PRO DEO Lots 9 & 10, Southview Heights Preliminary Development Plan

Project: Pro Deo Youth Ctr
Issue Date: December 6, 2023

OVERALL SITE PLAN
Preliminary Plans for:
Lot 9 & 10, Southview Heights
Lee's Summit, Jackson County, Missouri

REV. 1/5/2024

C.100

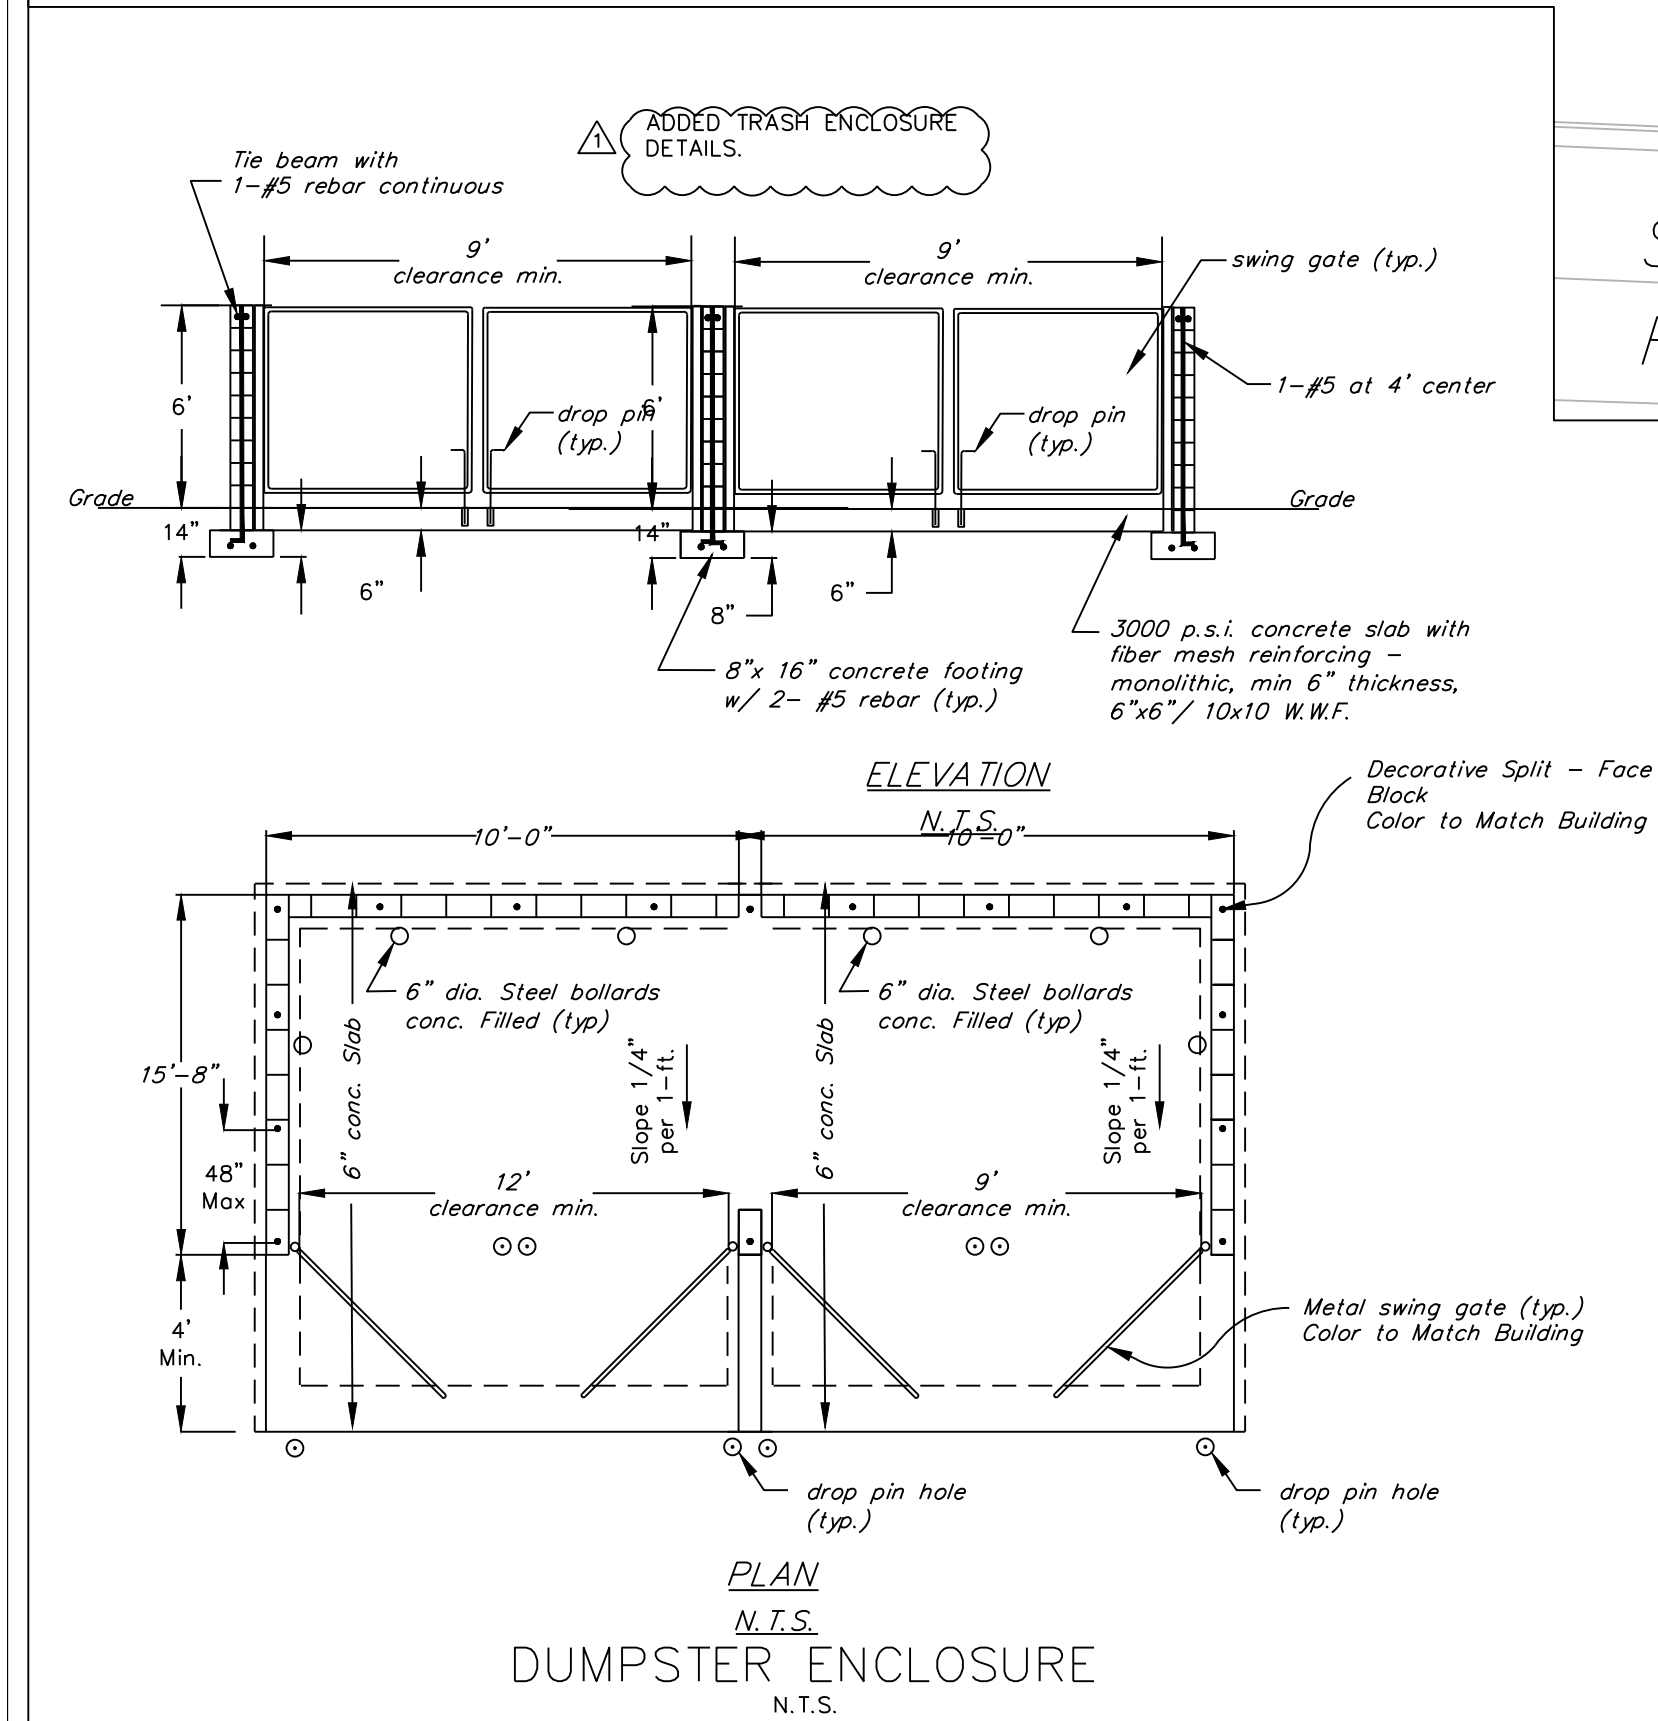
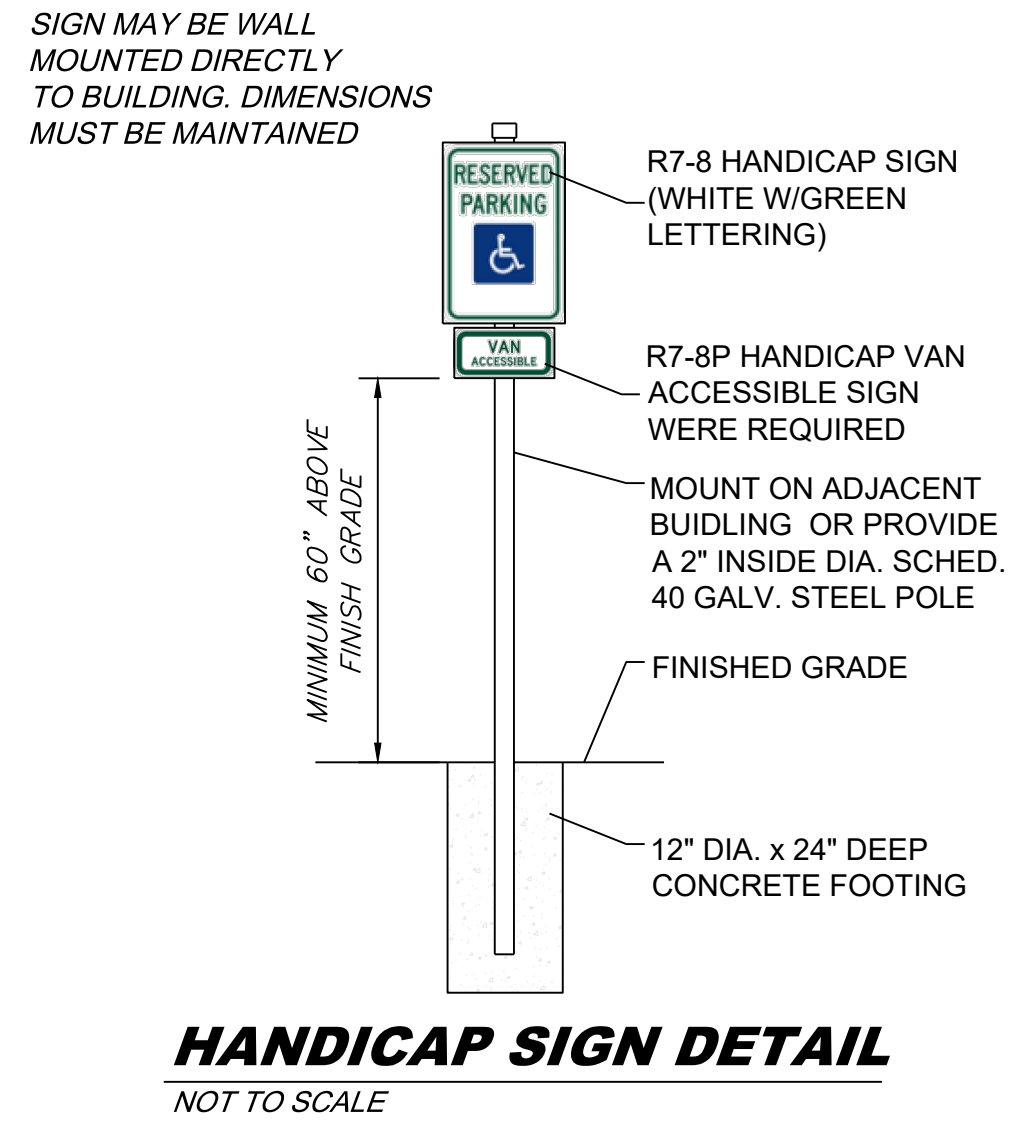
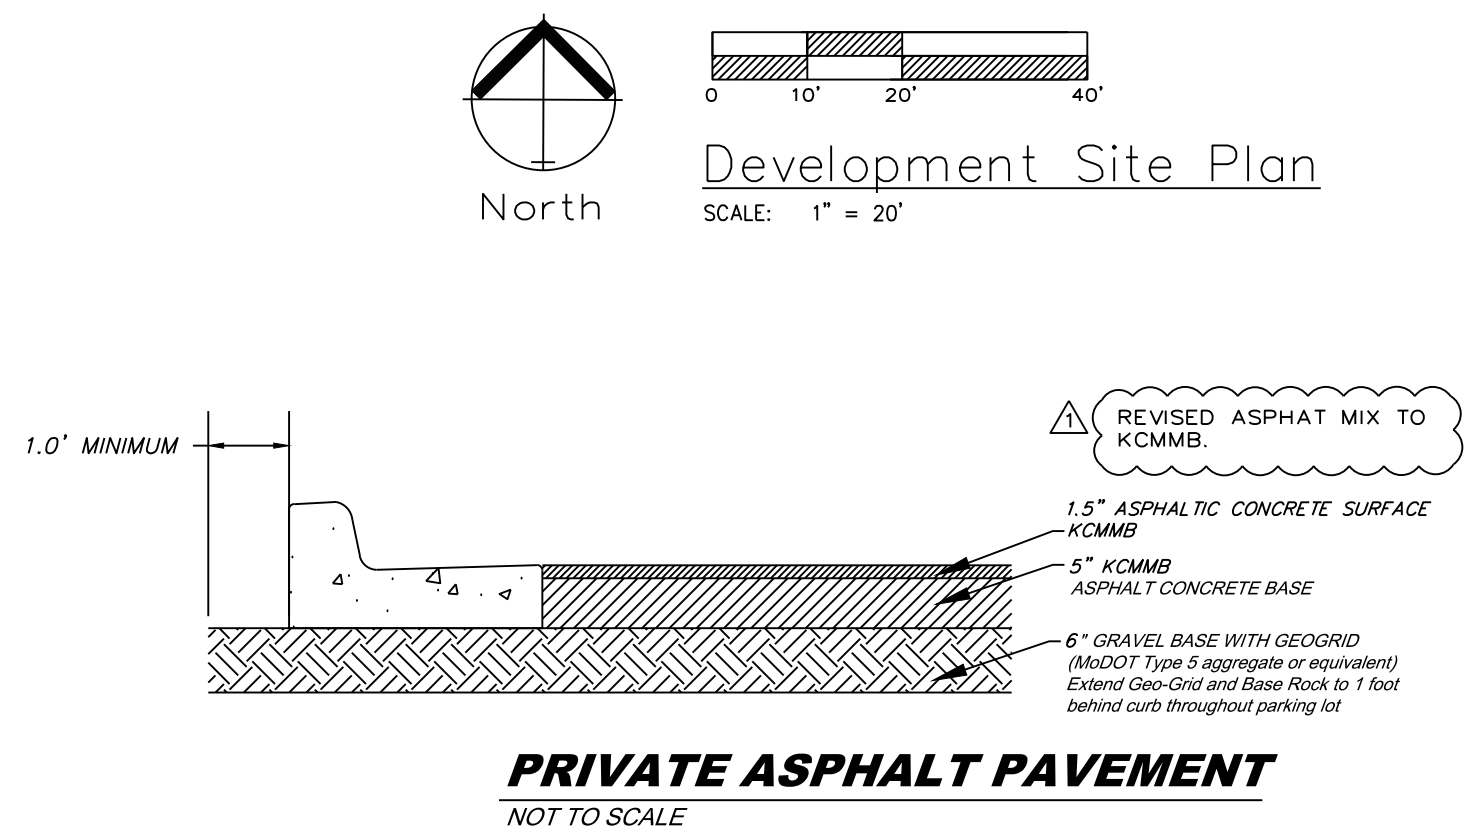
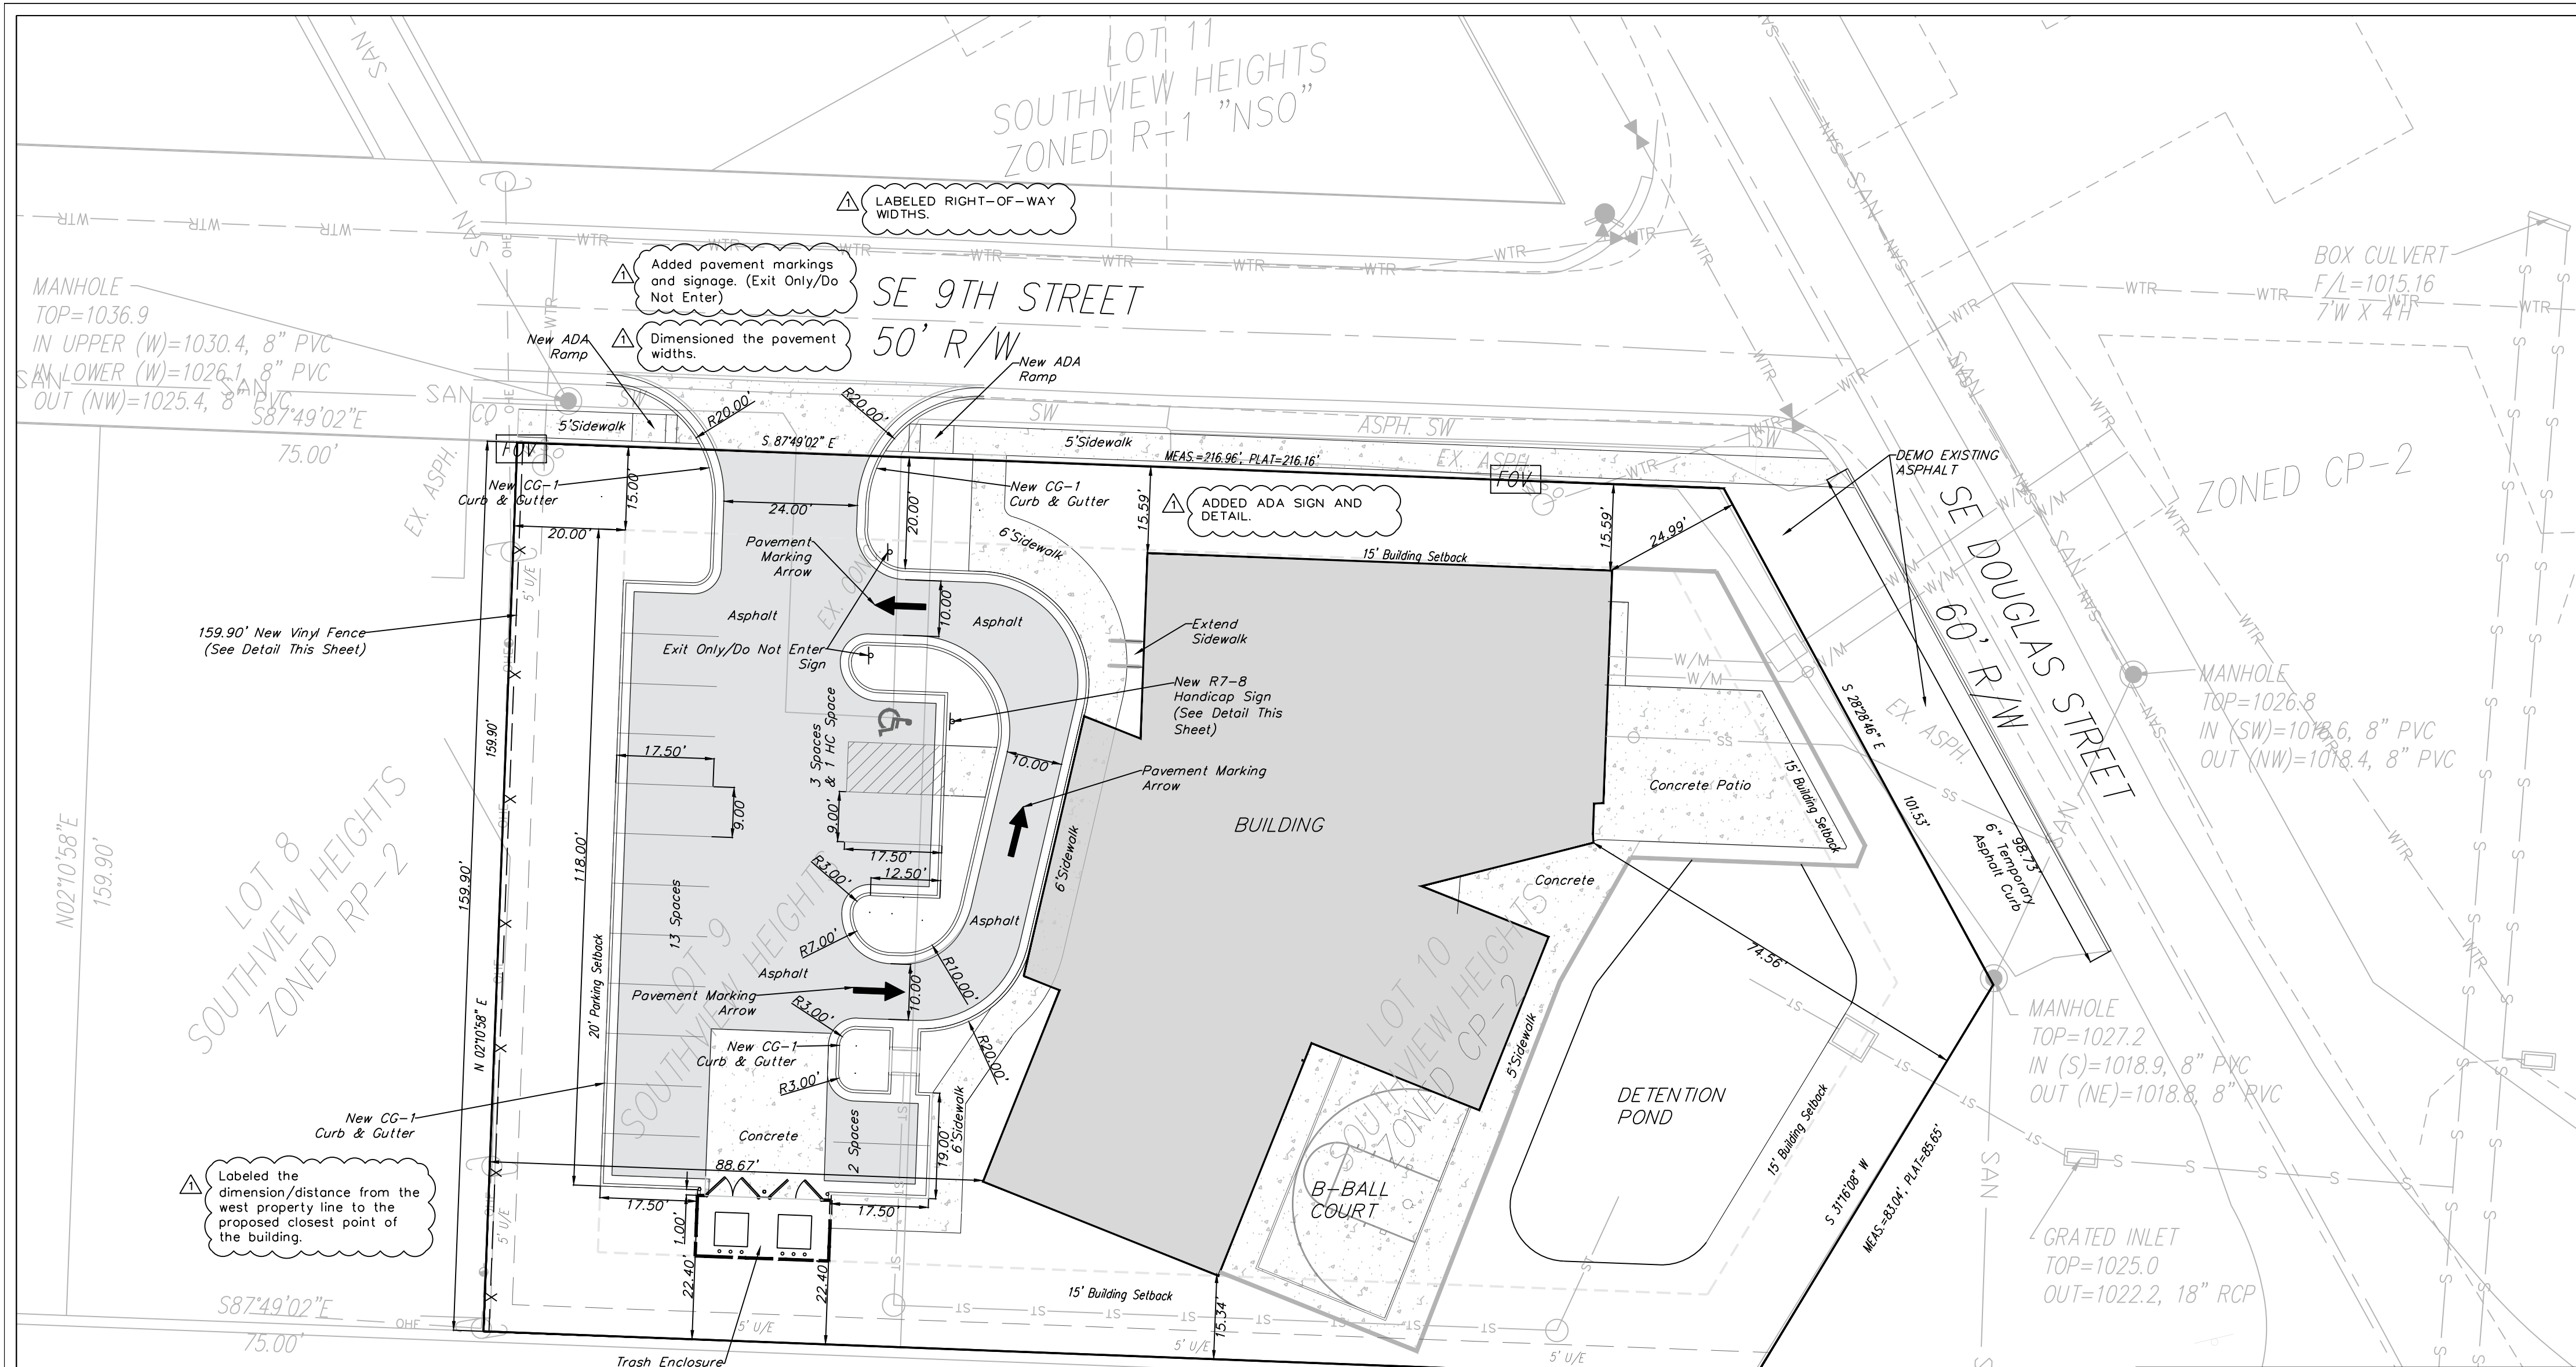
REVISD PARKING TOTAL.

REVISD ZONING.

Total Parking Spaces 17

Proposed Zoning: CP-2
